WAYII AREA TRAIL DESIGN INDEX SHEET

--	----	----
--	----	----
--	----	----
--	----	----
1	REVISED REST AREAS	21/03/10
0	ISSUED FOR TENDER	21/02/18

TOFINO
**PACIFIC RIM
NATIONAL PARK RESERVE**
ʔapsčik tašii
(Ups-cheek ta-shee)
**“Going in the right
direction on the trail”**

WAYII AREA TRAIL DESIGN

WALL 1
TYPICAL DETAIL - SINGLE WALL AT 0+250

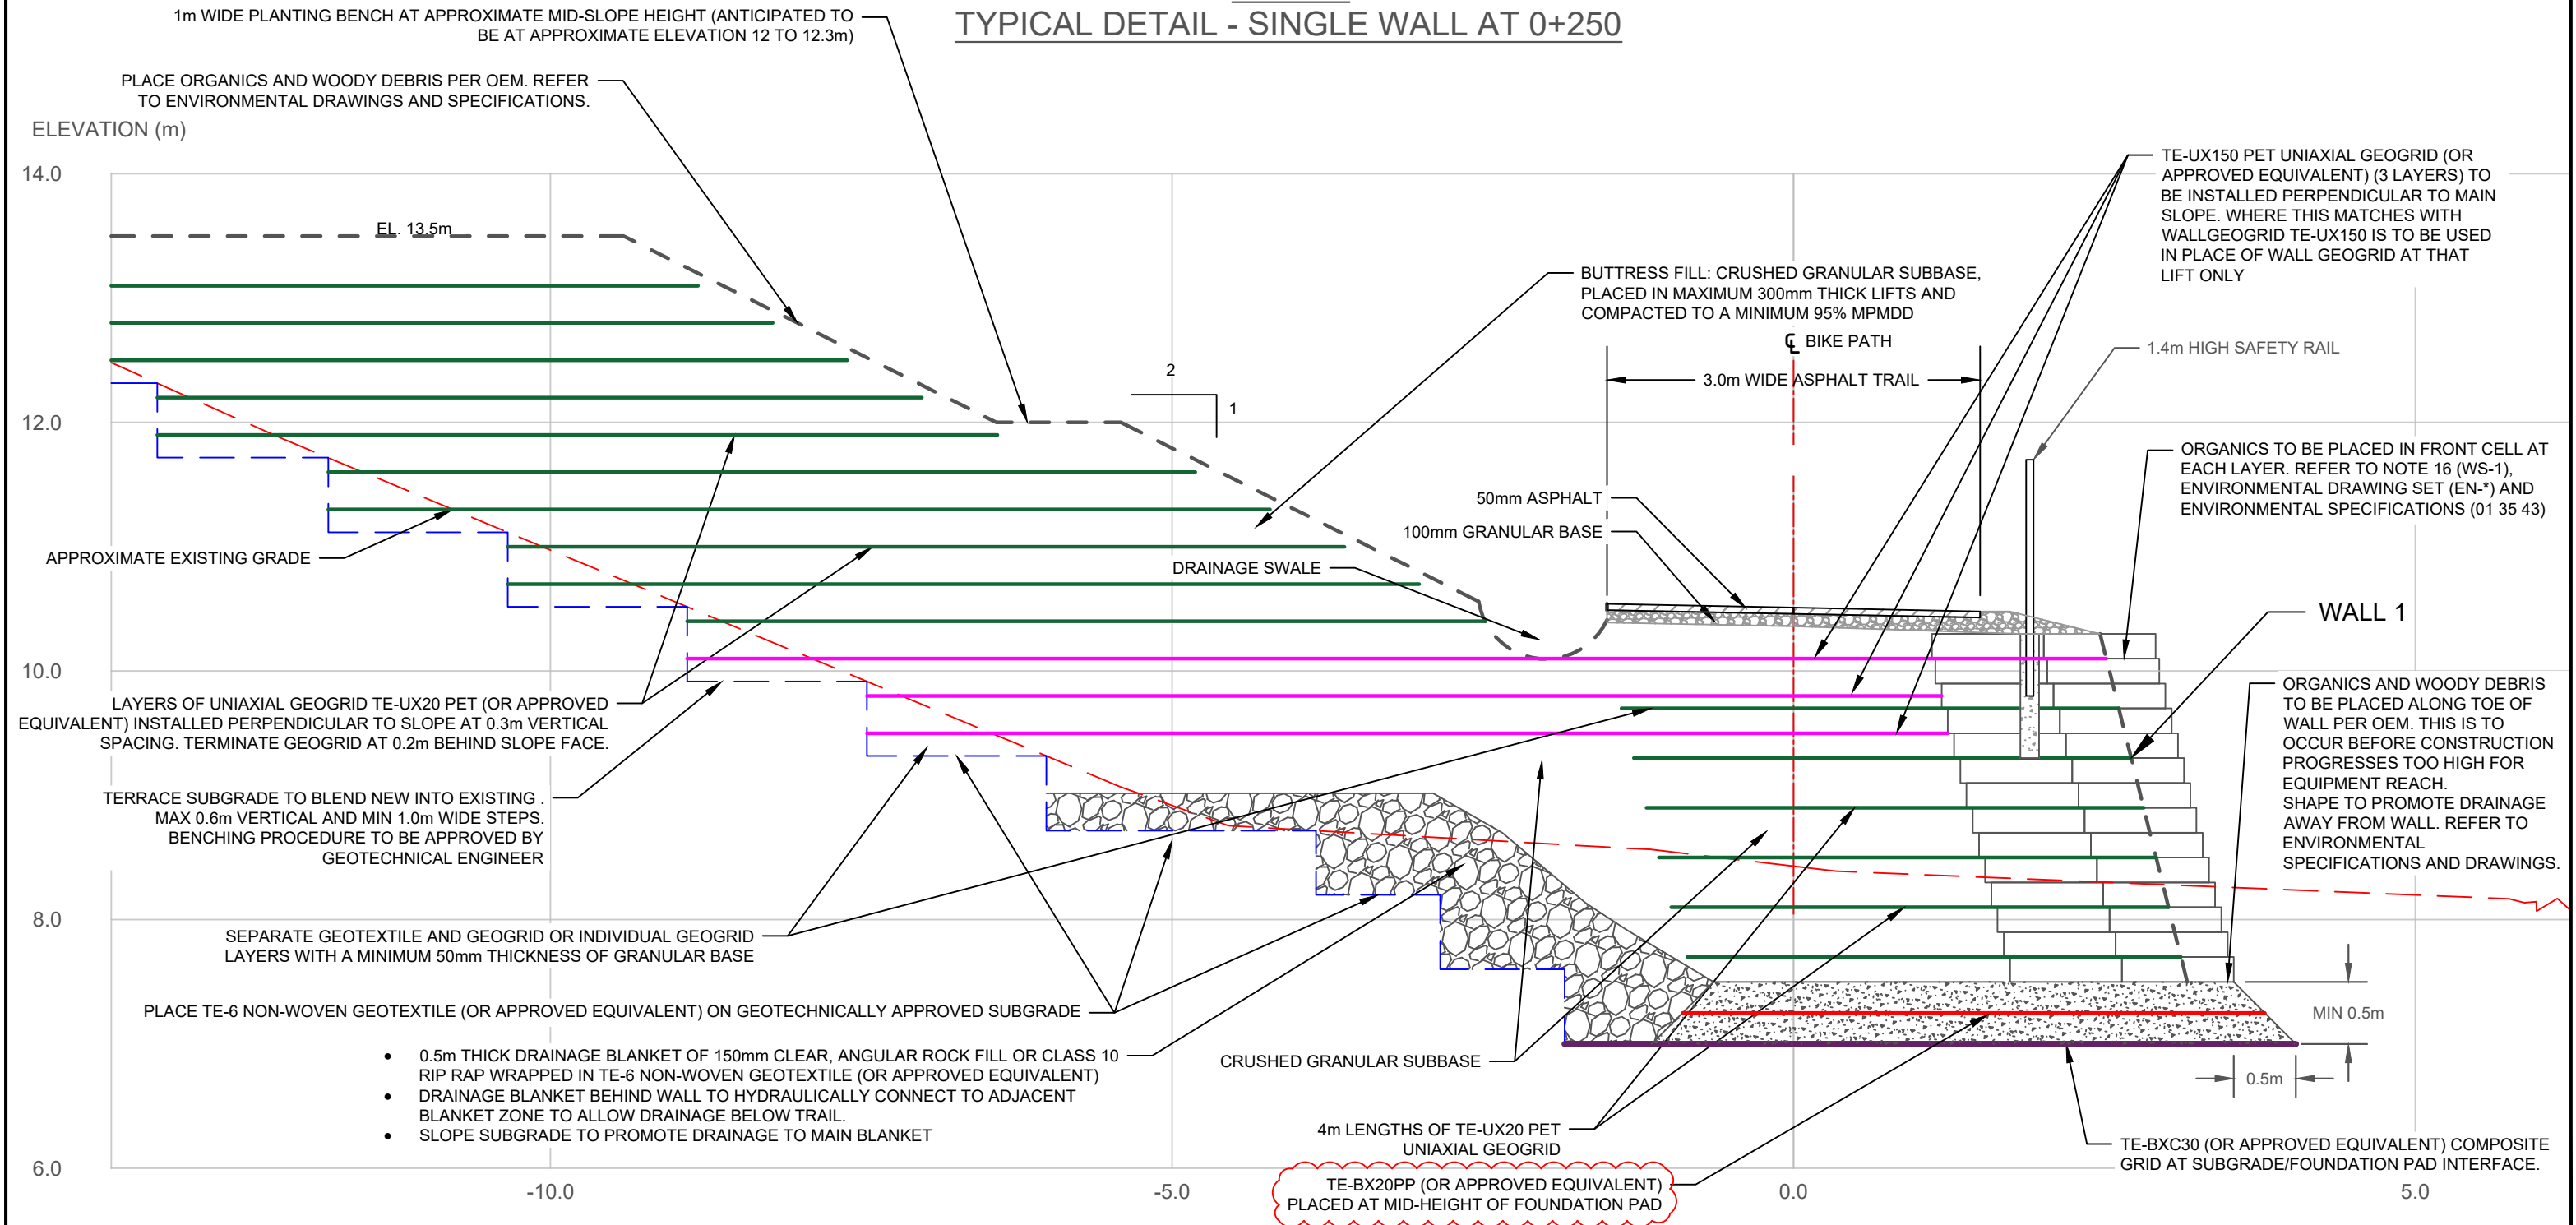
LEGEND:						PROJECT:	UPSCHEEK TASHEE MULTI-USE PATHWAY WAYII AREA TRAIL DESIGN (ESCARPMENT) PACIFIC RIM NATIONAL PARK RESERVE, TOFINO, BC	DATE:	FEB 2021	 WSP Canada Inc. 760 Enterprise Cres. Victoria, B.C. V8Z 6R4 P: 250.475.1000 www.wsp.com
							DESIGN BY:	DF		
							DRAWN BY:	BPK		
			1	BI-AXIAL GEOGRID REF	03/12/21	CLIENT:	PARKS CANADA	CHECKED BY:	DF	
			0	ISSUED FOR TENDER	02/17/21	TITLE:	WALL 1 DETAIL AND BUTTRESS DETAIL (STATION 0+250)	SCALE:	AS SHOWN	
REV. :	DESCRIPTION:	DATE : (M/D/YR)	THIS DRAWING IS THE SOLE PROPERTY OF WSP CANADA INC. AND CANNOT BE USED OR DUPLICATED IN ANY WAY WITHOUT THE EXPRESSED WRITTEN CONSENT OF WSP. THE GENERAL CONTRACTOR SHALL VERIFY ALL DIMENSIONS AND REPORT ANY DISCREPANCIES OR OMISSIONS TO WSP.				PROJECT No.:	191-08875-02	FIGURE NO.:	WD-3
